Lavender Suites

4519 18th Ave NE

DPD # 3016870

Design Review
Recommendation
8 June 2015

CS-1 Solar Exposure

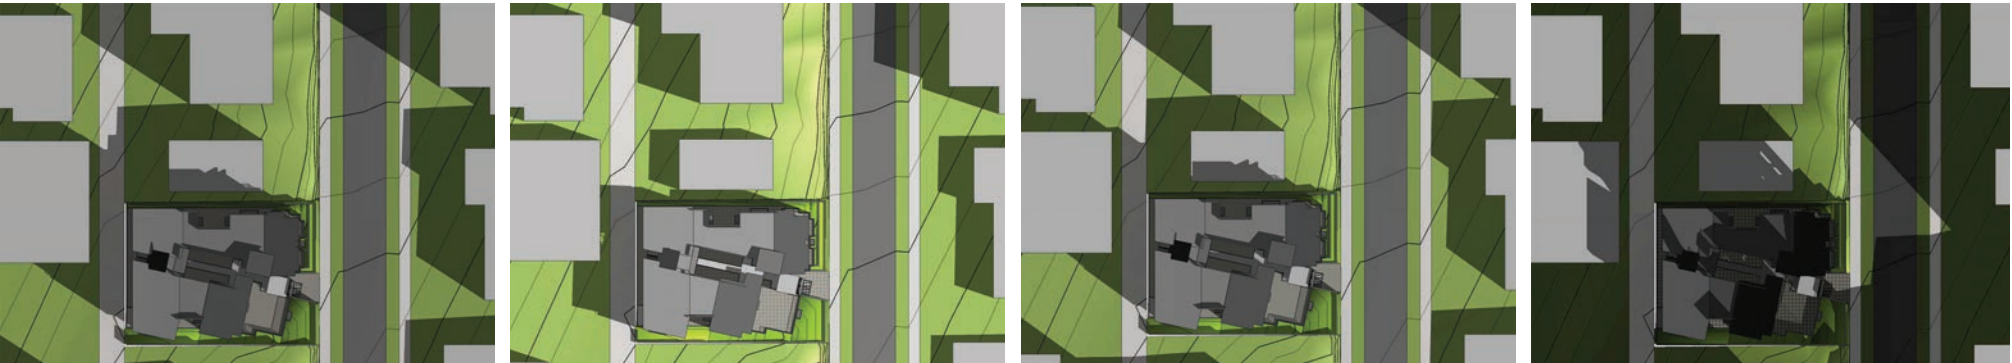
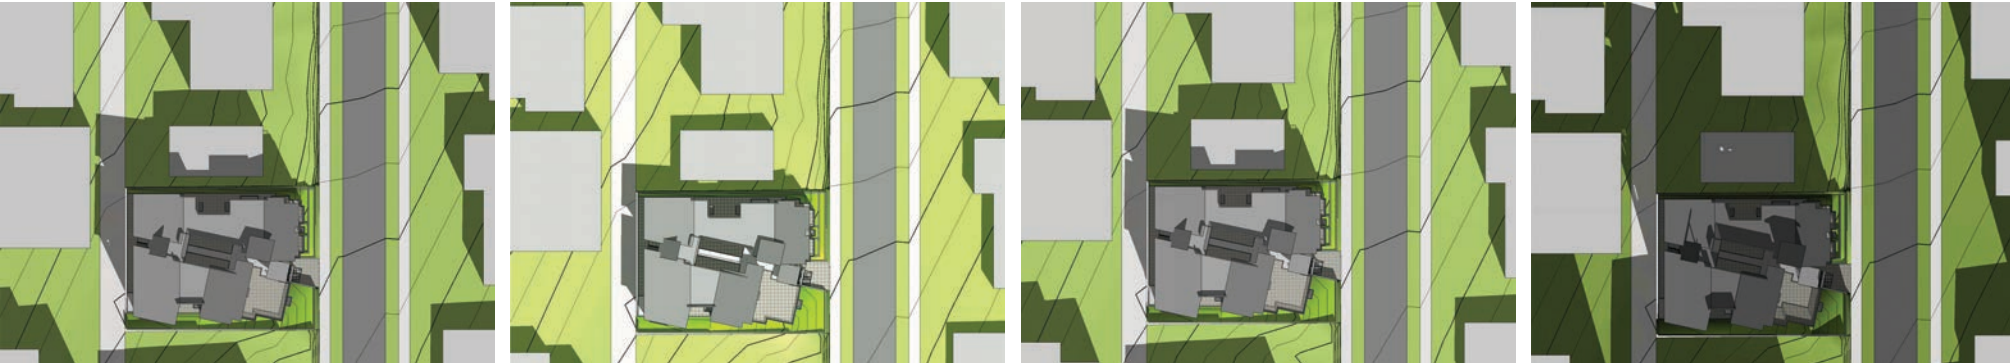
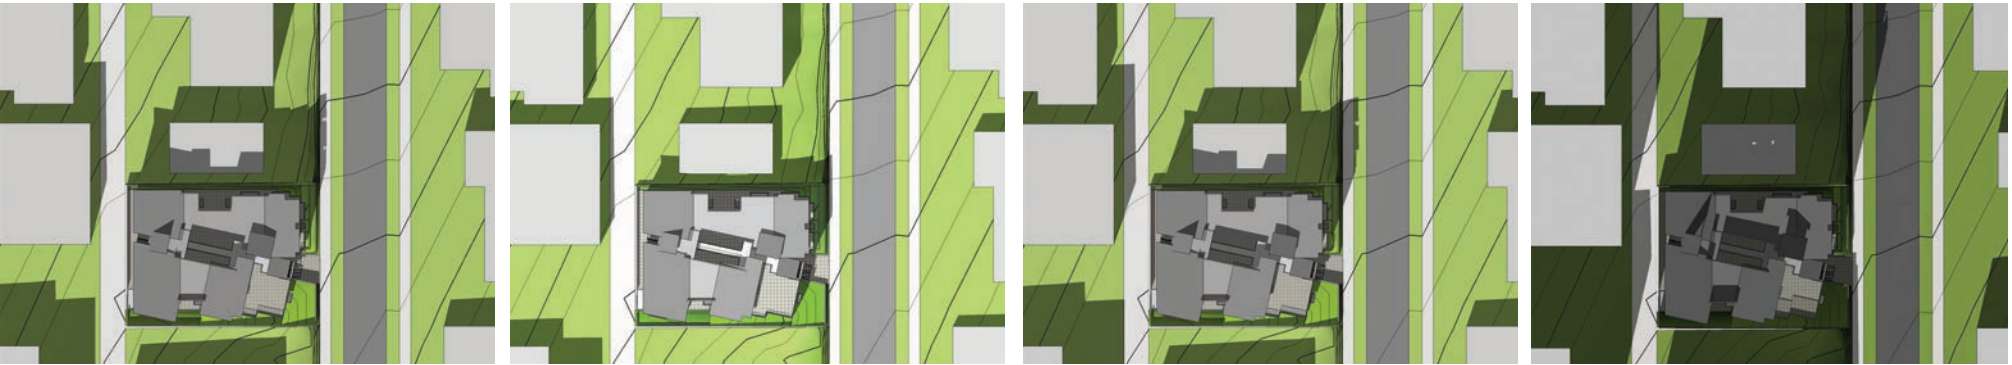
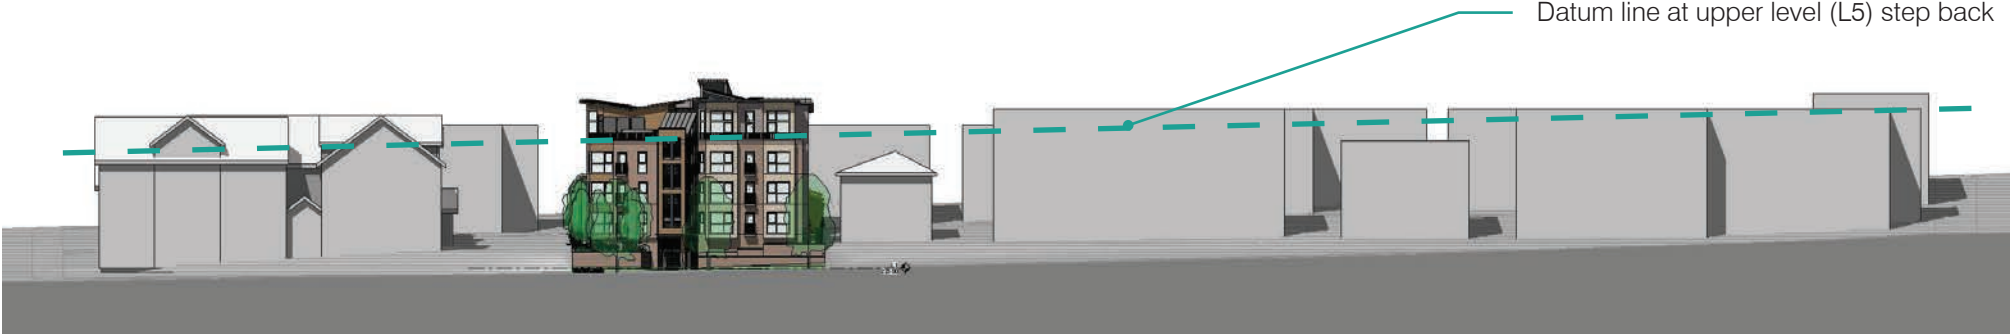
- I. Streetscape Compatibility:
- I-i. Solar Exposure:
Minimizing shadow impacts is important in the University neighborhood. The design of a structure and its massing on the site can enhance solar exposure for the project and minimize shadow impacts onto adjacent public areas between March 21st and September 21st. This is especially important on blocks with narrow rights-of-way relative to other neighborhood streets, including University Way, south of NE 50th Street.

Response:
The building does cast shadows on the adjacent property to the North as would be expected by any project built to the current zoning envelope. Stairs, elevator and solar collectors are located away from the North property line to minimize their added effect on solar shading.

DC-4 Property Line Fences

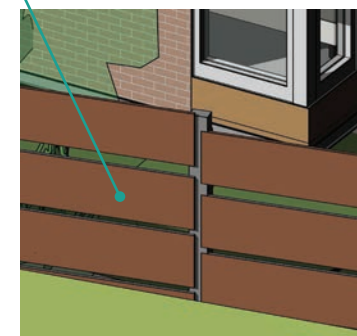
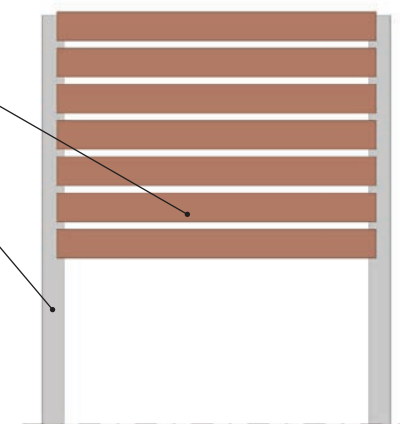
- A. Provide details of the side yard fences including materials. (See p. 39)

Wood plank fence, 1 x 8 x 1 green Western Red Cedar, stained, steel poles on c.i.p. concrete stub wall, 5'-0' high, typ.

DC4-D Landscape Plan

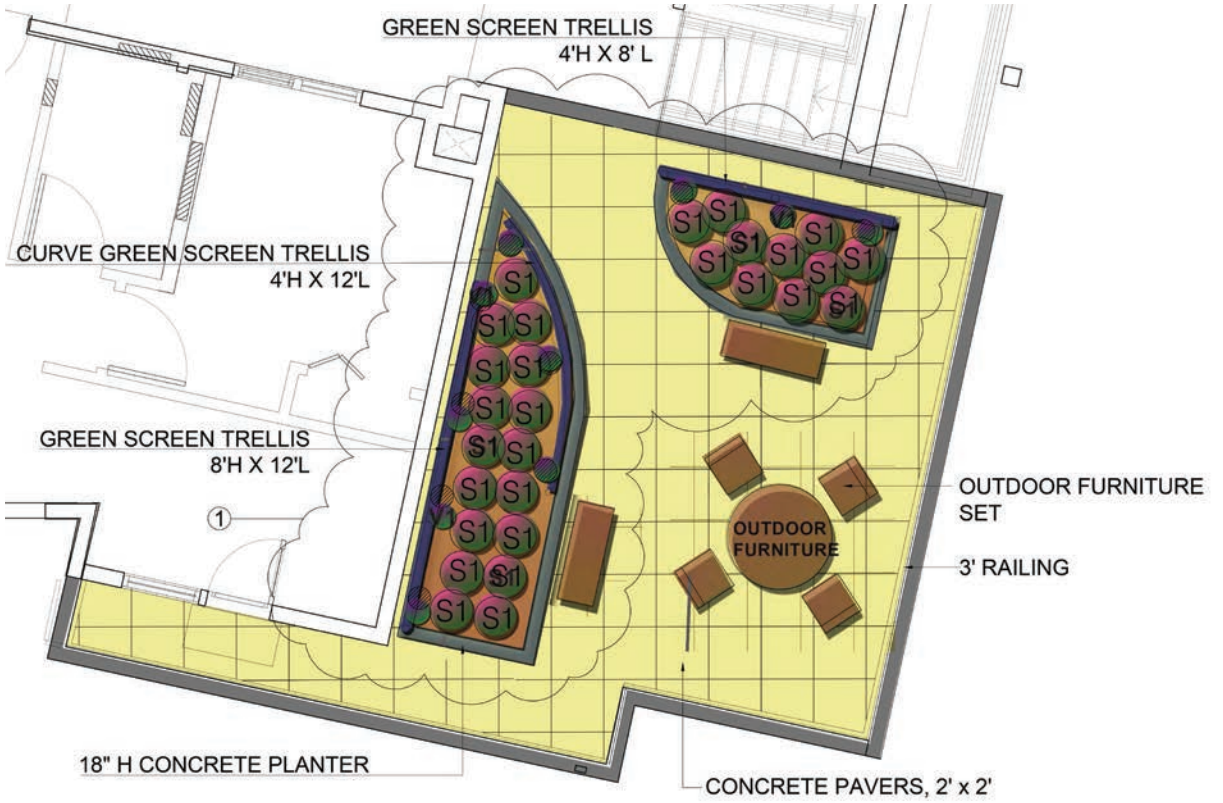
DPD :
“Provide fewer trees than the landscaping plan proposed, but trees planted should be larger. (DC4.D.3&4)”

DPD :
“Make sure landscape plan includes gates, fences, steps, etc. Indicate all paved surfaces and what the material is.”

DPD :
Confer with the City Arborist that the proposed street trees are an appropriate species. Clarify on the plans which species are proposed.

Response from Landscape Architect:
The DPD Green Factor requirement for this project is 0.6, so it's impossible for us to reduce the size of any tree in the landscaping plan because we only have 0.603 GF credits.

The landscaping area is narrow and small around the building and within the retaining wall structures, i f we plant big trees, their roots will damage these structures in the future.

The trees that function as a screen to the neighborhood are T1 Emerald Sunshine Elm (H: 35'), T2 European Hornbeam (H: 30' to 40'), and T3 Columnar Norway Maple (H: 50' to 60') and they are large enough in our opinion. The T4 Eastern Redbud (H: 20' to 30') and Sango Kaku Japanese Maple (H: 20') are plants to increase the seasonal changes for this landscaping garden.

Response from Landscape Architect:
The Landscape Planting Plan L-1 has included gates, fences, and steps as shown on the site plan.

The yellow surface on the inside and along the building are concrete pavers (sized 2' x 2'), and the curved walkway and circle patio are smaller concrete pavers (sized from 6" to 8") to make these curved shapes possible.

Response from city:
“ ... I recommend calling out Emerald Sunshine elm (Ulmus propinqua 'JFS Bieberich'), about 30-feet OC. They will be a nice, rugged tree for this area....”
